ind Management Parameters for 10 Mb/s Operation and Associated Power Delivery over a Single Balance

and Management Parameters for 10 Mb/s Operation and Associated Power Delivery over a Single Balance

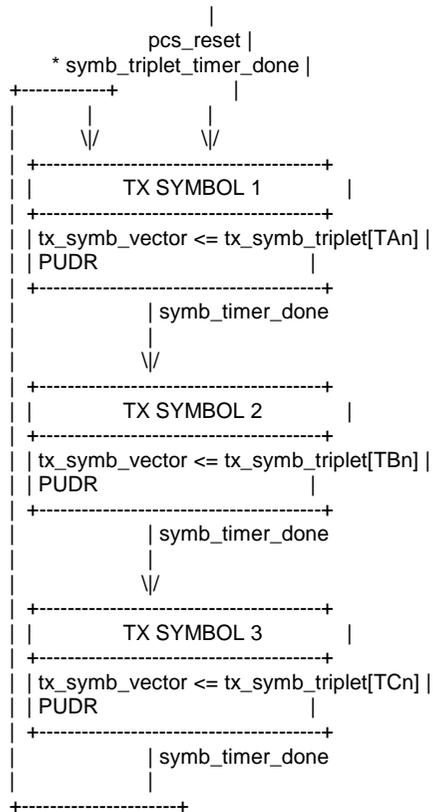
Cl 146 SC 146.3.3.1 P 117 L 18 # i-341  
 Law, David Hewlett Packard Enterprise  
 Comment Type T Comment Status A EZ  
 Suggest that 'In each symbol period, PCS Transmit generates a ...' should be changed to read 'In each symbol period, the PCS Transmit function generates a ...'.  
 SuggestedRemedy  
 See comment.  
 Response Response Status C  
 ACCEPT.

Cl 146 SC 146.3.3 P 117 L 18 # i-342  
 Law, David Hewlett Packard Enterprise  
 Comment Type TR Comment Status A State Diagram  
 Is it correct that 'The PCS Transmit function shall conform to the PCS Transmit state diagram in Figure 146-5 ...' and that 'In each symbol period, PCS Transmit generates a symbol An provided to the PMA ...'? The PCS Transmit state diagram in Figure 146-5 changes state based on STD being true, with STD being an alias for symb\_triplet\_timer\_done, and the output of the PCS Transmit state diagram is tx\_symb\_triplet which is defined in subclause 146.3.3.1.1 'Variables' as 'A triplet of ternary symbols generated by the PCS Transmit function after 4B3T encoding.'  
 I think the problem is that there is another function within the PCS Transmit function that is missing from the PCS Transmit state diagram in Figure 146-5, the 'multiplexor' shown in Figure 146-6 'PCS transmit symbol generation'. This 'multiplexor' function operates at the symbol clock rate and serialises the tx\_symb\_triplet code-groups output by the PCS Transmit state diagram into individual symbols.

This may also explain when subclause 146.3.3.1.3 'Timers' defines the symb\_timer that is not used in the PCS Transmit state diagram in Figure 146-5.  
 SuggestedRemedy  
 [1] Insert a new subclause 146.3.3.2 titled 'PCS Transmit multiplexor state diagram' that reads 'In each symbol period, the PCS Transmit multiplexor generates a ternary symbol that can take the values of {-1, 0, +1} and passes it to the PMA sublayer via the PMA\_UNITDATA.request primitive. The nominal symbol clock frequency is specified in 146.5.4.5.'. Renumber the following subclauses as required.  
 [2] Add a new subclause 146.3.3.2.1 titled 'Variables' that reads:  
 pcs\_reset  
 The pcs\_reset parameter set by the PCS Reset function.  
 Values: TRUE or FALSE  
 tx\_symb\_vector  
 A ternary symbol generated through serialization of tx\_symb\_triplet. This symbol is conveyed to the PMA as the parameter of a PMA\_UNITDATA.request(tx\_symb\_vector) service primitive.
